TECHNICAL MEMORANDUM

DATE: July 27, 2015

SUBJECT: Conceptual Design for Sonoita Creek, AZ, Technical Review Support (Order Number EP-G149-00241)

Figure 2a. Hydrologic soil group map and color-coded ratings for Sonoita Creek area (see next page for map legend).

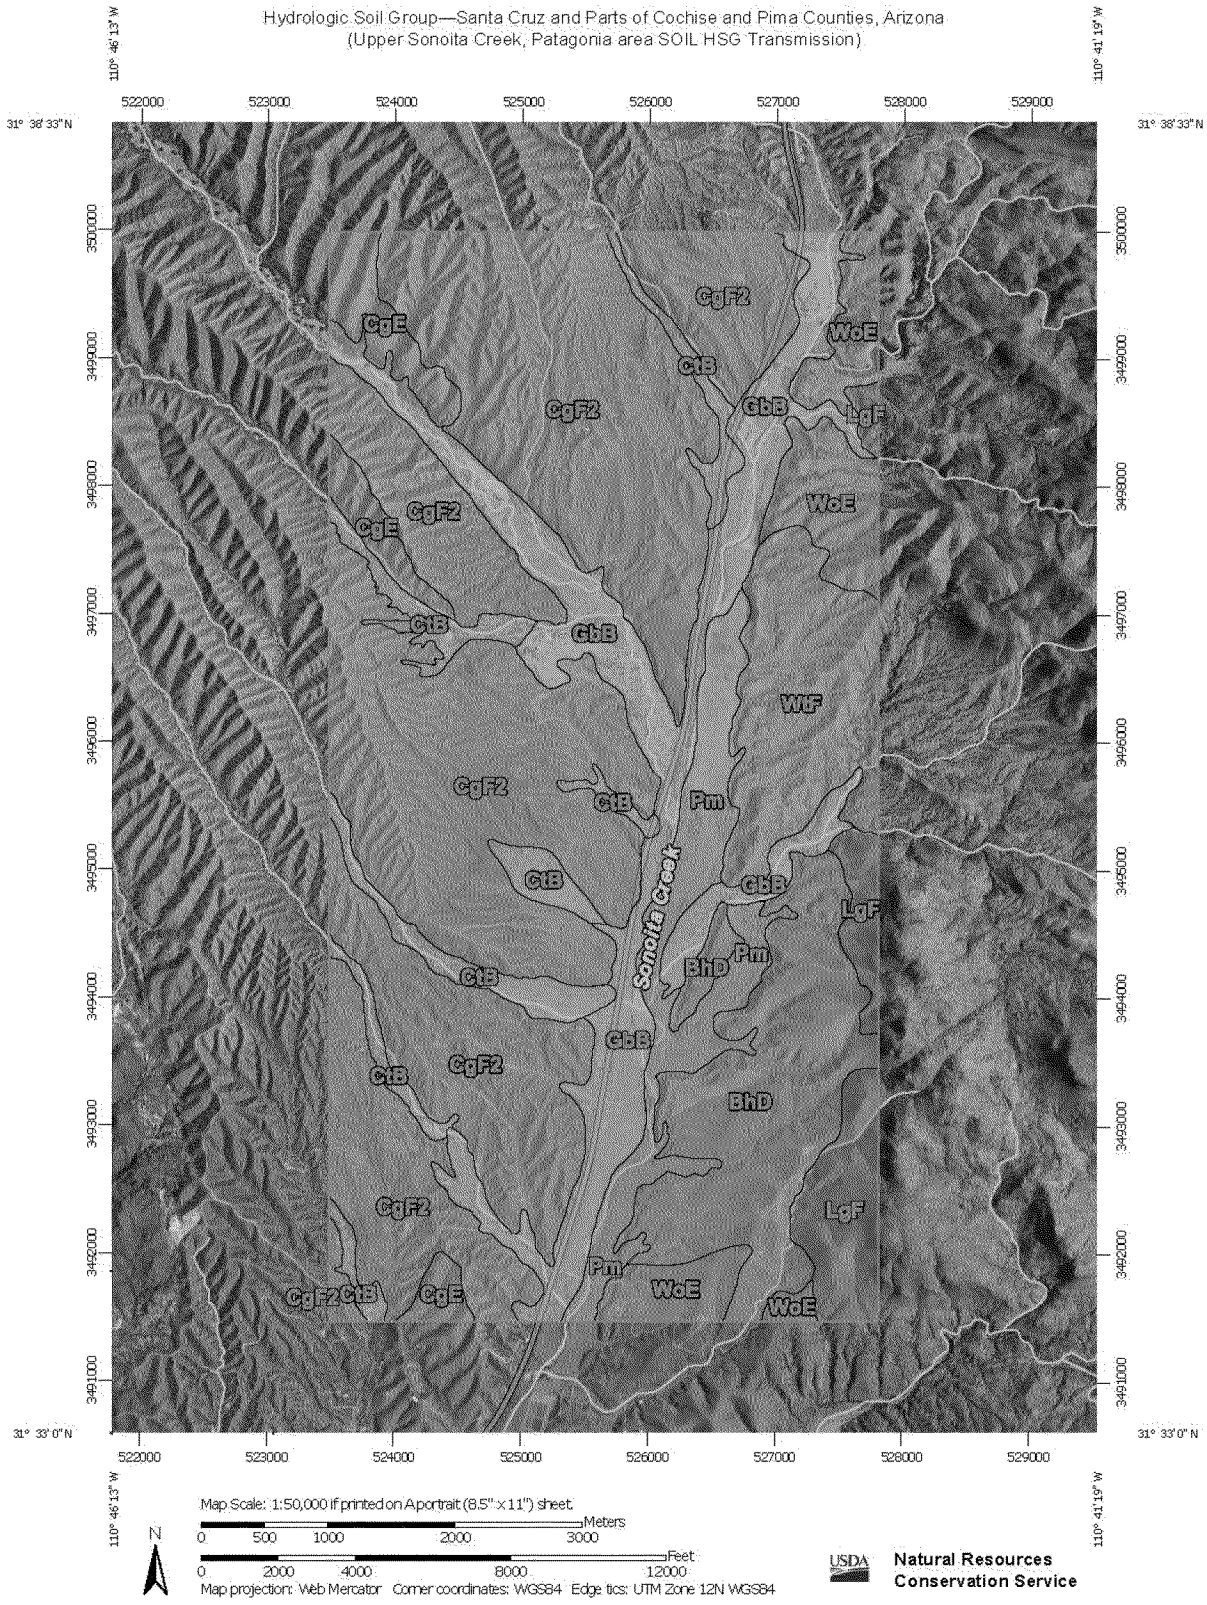
3) **The proposed constructed channels will likely not sustain flow in the specific soil types within the project reach.** The Sonoita Creek valley bottom consists primarily of alluvial deposits. In terms of mapped soil units, it is dominated by Grabe-Comoro complex (GbB) soils of gravelly sandy loam to sandy loam composition, that receive a hydrologic soil group classification (HSG) of Group A (refer to Figure 2a and 2b). Group A soils are characterized by high infiltration rates, low runoff potential, and a high rate of water transmission. The Sonoita Creek floodplain also has a lesser percentage of Pima soils (Pm), a clay loam that receives a HSG classification of Group C. Group C soils are characterized by slow infiltration rates and slow water transmission.

Transmission losses due to infiltration into the bed and banks are high in semiarid ephemeral streams, and multiple researchers have demonstrated that except during the highest flows, there is significant loss of in-stream flow due to seepage as the flow proceeds downstream in alluvial valleys (Levick, et al. 2008). The WET report (p.12) notes that transmission losses for streams like Sonoita Creek have been reported as high as 17-29%. Approximately half of the constructed pilot channels as proposed in the plan would be excavated into the highly permeable Grabe-Comoro complex soils, resulting in high transmission losses. Any portion of the flow that entered the newly constructed channels during low to moderate flow rate events, such as those that occur at a high frequency annual scale, would likely not be sustained, and likely not return to the main Sonoita Creek channel. Sediment drops out of suspension as infiltration occurs and flow drops in velocity, depositing new material in the channel. Resulting aggradation may fill the newly constructed channels, further restricting the ability of flows to be diverted and for any diverted flow to successfully return to the main Sonoita Creek channel, particularly at the downstream reaches of constructed channels. Continued aggradation in the constructed channel could eventually create an abandoned, non-functional channel. The overall result would be a loss of habitat in the main channel of Sonoita Creek and a failure to create new habitat in the constructed channels, therefore failing to meet the stated goals of the proposed design in the WET report.

Figure 3. Patagonia and Sonoita Creek area from 1935 Fairchild flight number C-3250. The current modern day location of state highway 82 is shown in red for reference.

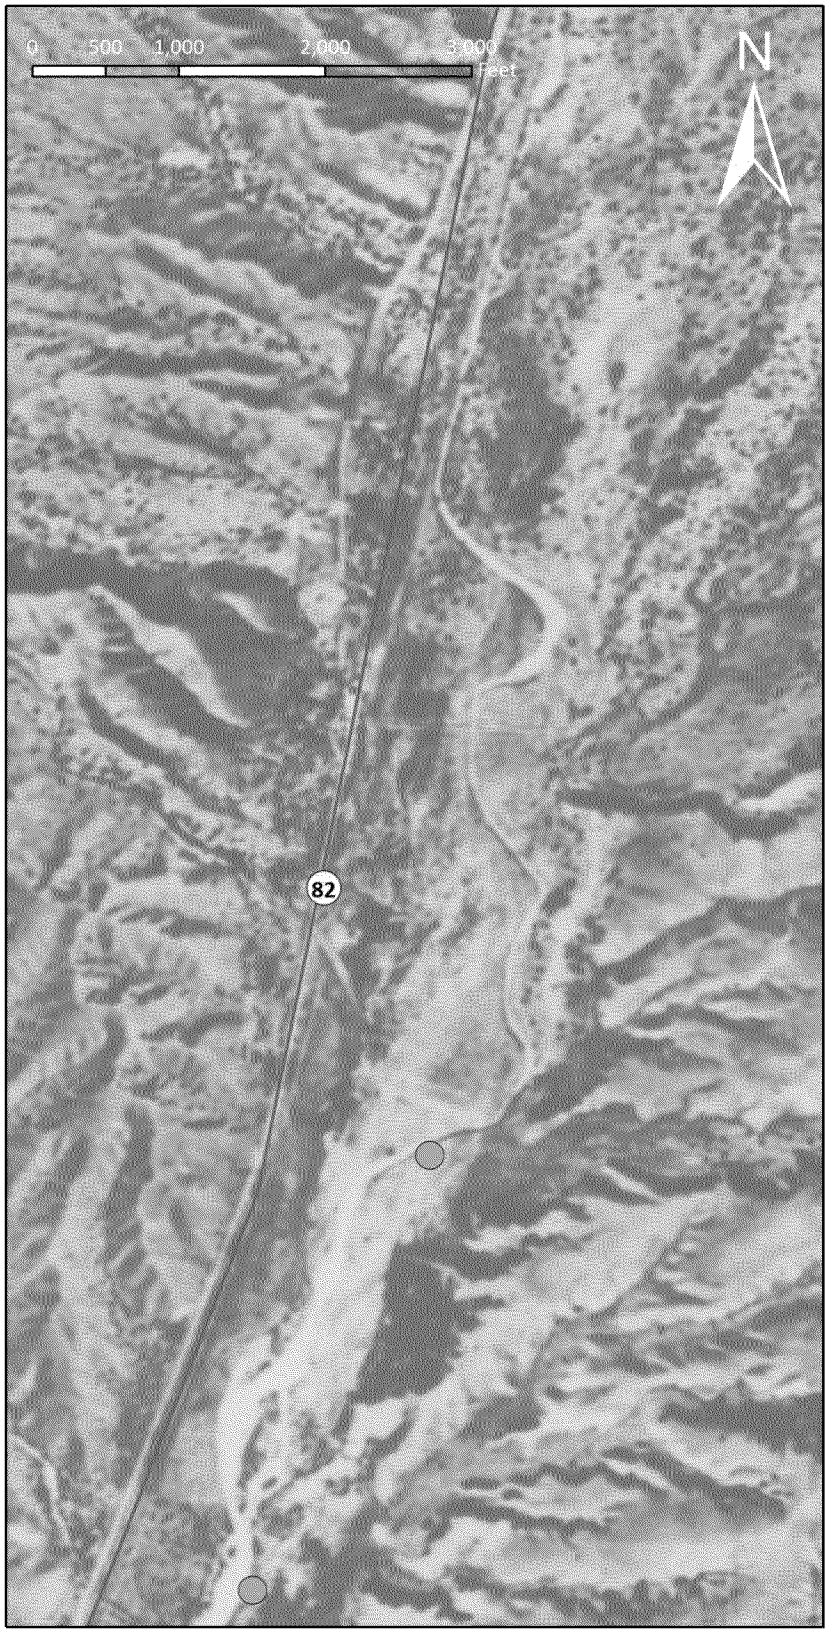
The WET report implies that Sonoita Creek in the project reach formerly had distinct, stable, multiple channels from the use of terms such as "restore and extend various reaches of stream channel" (p.1) and "reestablishing the benefits associated with typical unconstrained channel morphology in the area" (p.3). The WET report did not present any historical evidence to support the notion that Sonoita Creek formerly had multiple, stable channels. Fluvial geomorphologists usually consult historical sources for insights into river behavior that can inform restoration approaches (Kondolf and Larsen 1995). While a full historical channel analysis was beyond the scope of our review, we did obtain aerial photographs covering the Sonoita Creek valley in 1935. This historical imagery demonstrates that, as of 1935, Sonoita Creek was mostly a single-thread channel through the project reach (Figure 3, 3a, and 3b). The historical imagery does not display multiple, stable channels on Sonoita Creek, and as noted above, such a stable multi-channel configuration would not be expected in a dynamic semi-arid stream such as Sonoita Creek.
